September 14, 2018

**Re: Response to Comments on the Conceptual Site Model for the Chambers Works Facility,
Deepwater, New Jersey**

CHEMOURS CHAMBERS WORKS COMPLEX
DEEPWATER, NEW JERSEY

PROPOSED WELL LOCATION MAP

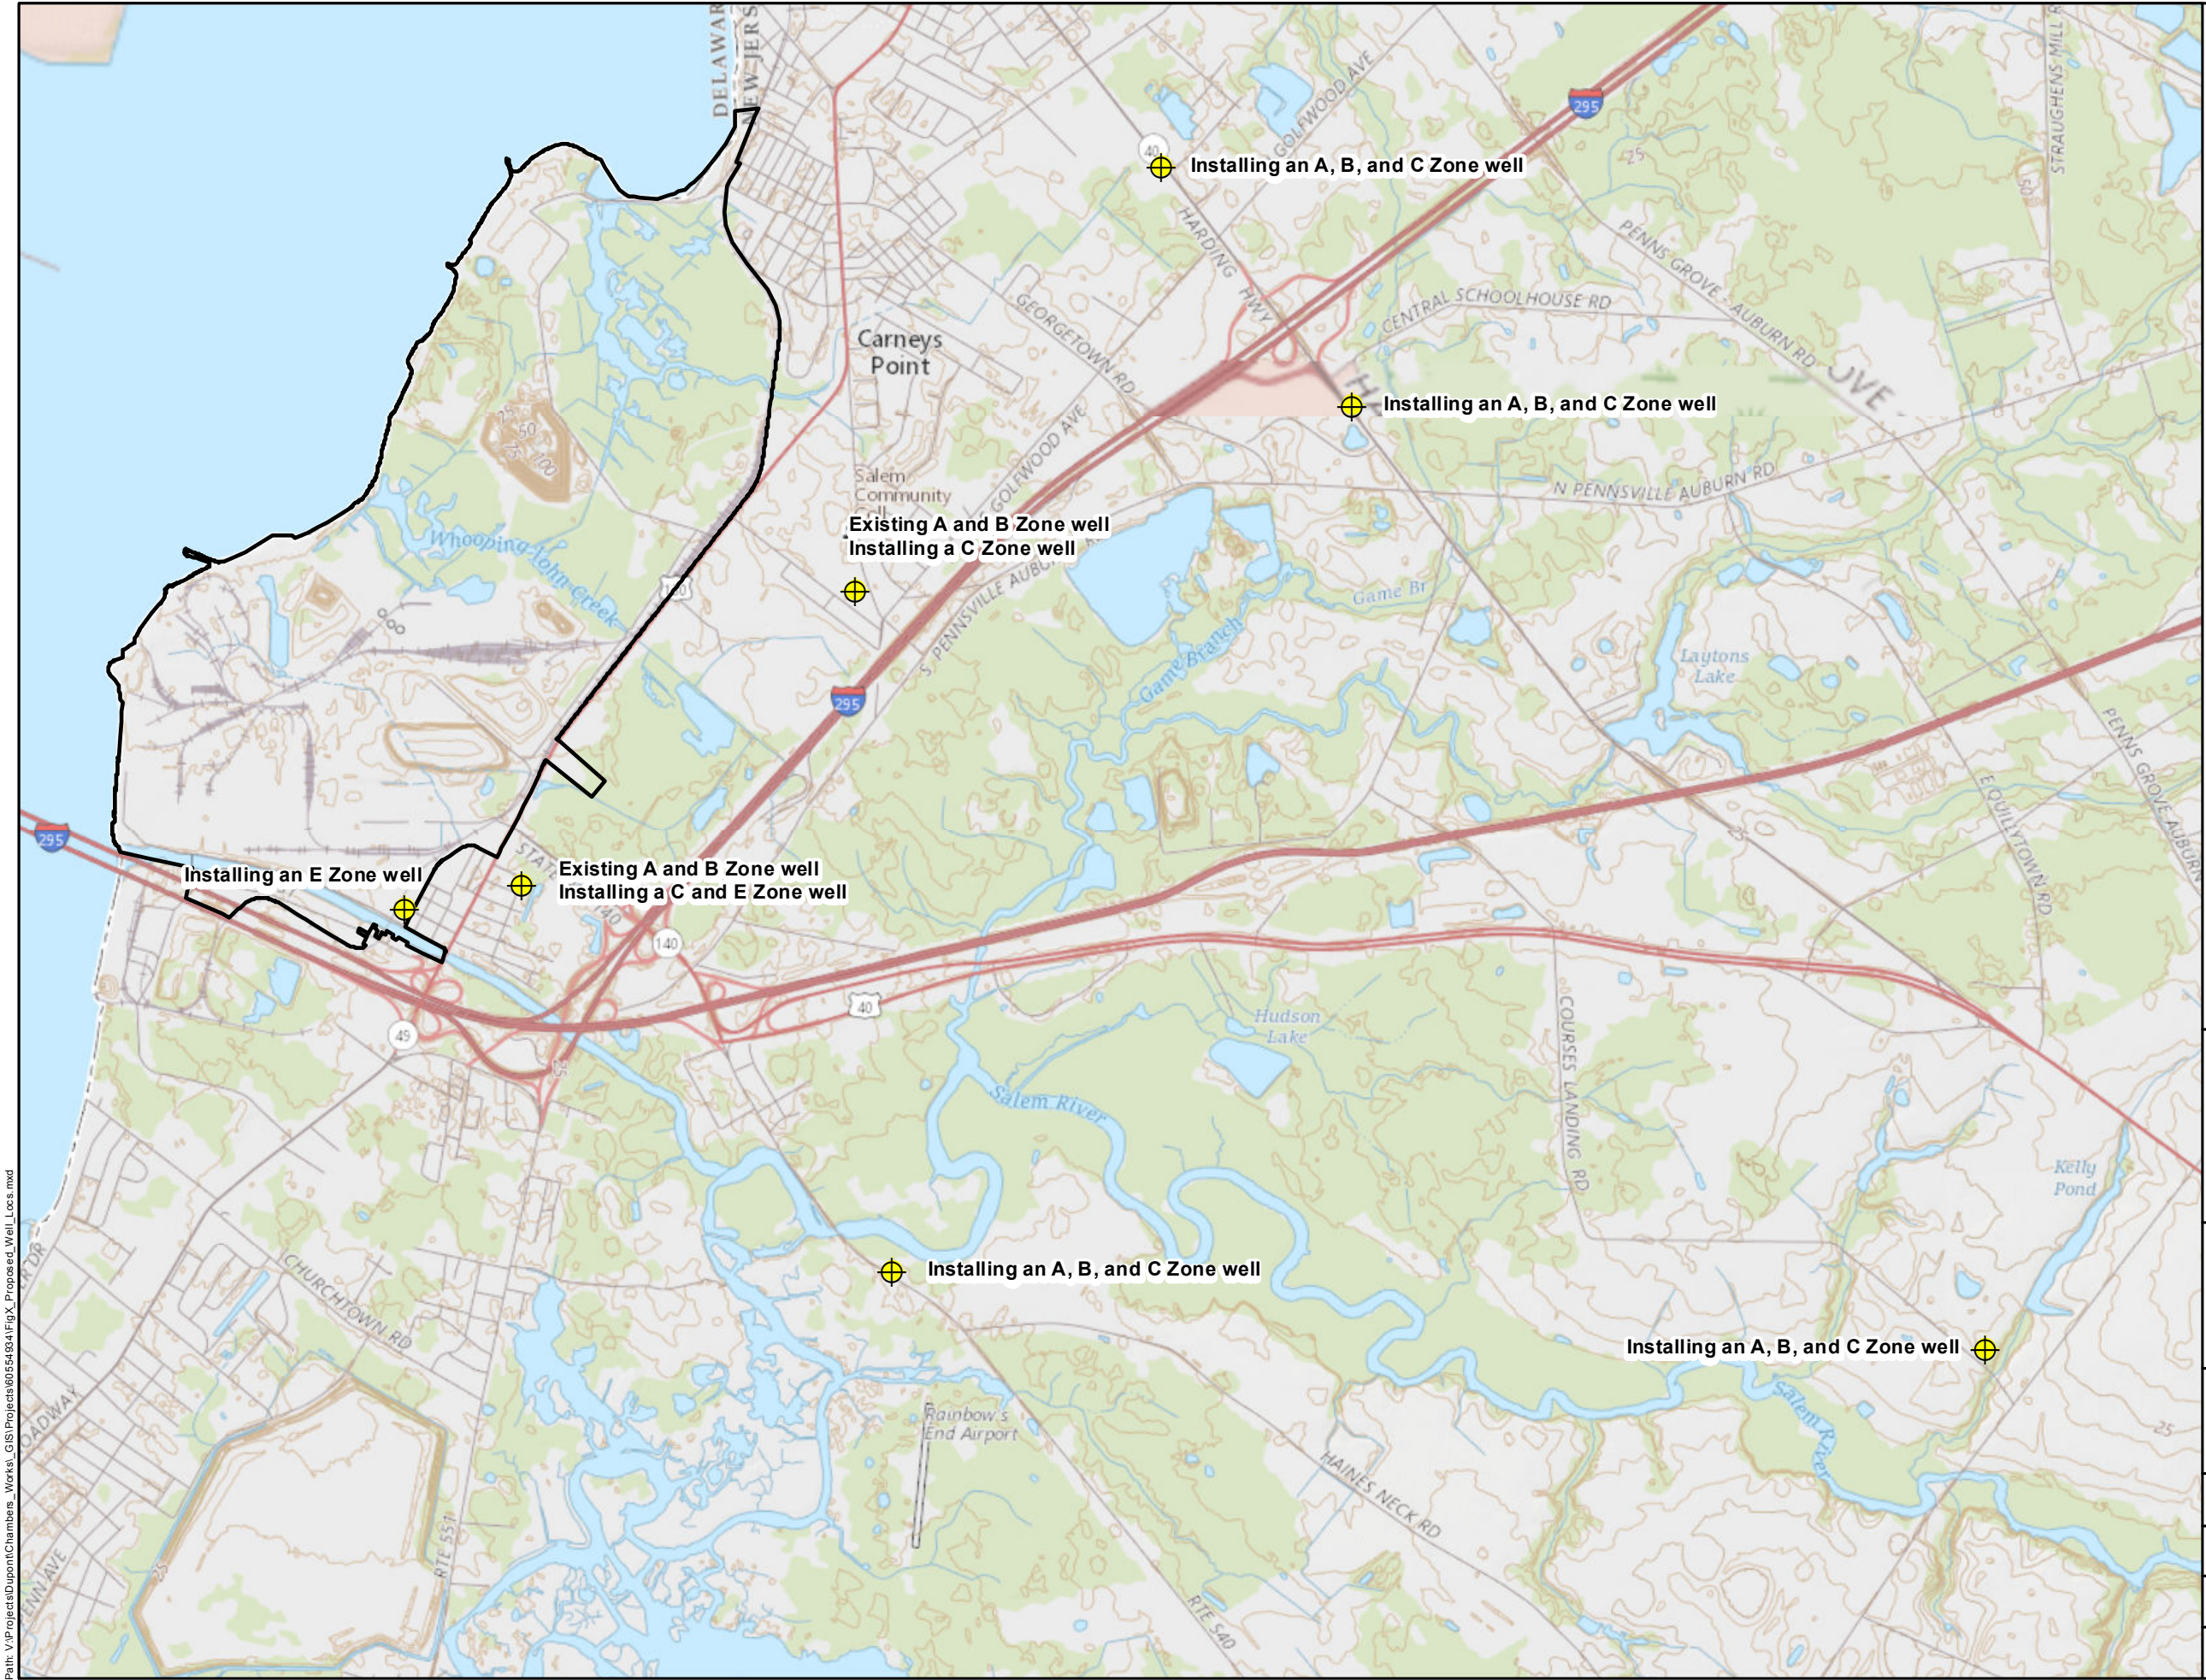
Comment 3: Delineation of Off-Site Groundwater Contamination Plume: As we have previously discussed, the installation and sampling of additional off-site monitoring wells by Chemours is necessary for the full delineation of site-related PFAS, and HFPO Dimer Acid, in the off-site groundwater contamination plume. Once there is full delineation of the horizontal and vertical extent groundwater contamination found off-site, the CSM should be updated, taking into account the effect of off-site groundwater pumping wells.

Response: Chemours is proposing to install clustered monitoring wells at multiple off-site locations as shown on the attached figure. These proposed locations, as well as a date for the creation of an integrated revised PFAS CSM, can be discussed at the September 19th quarterly meeting.
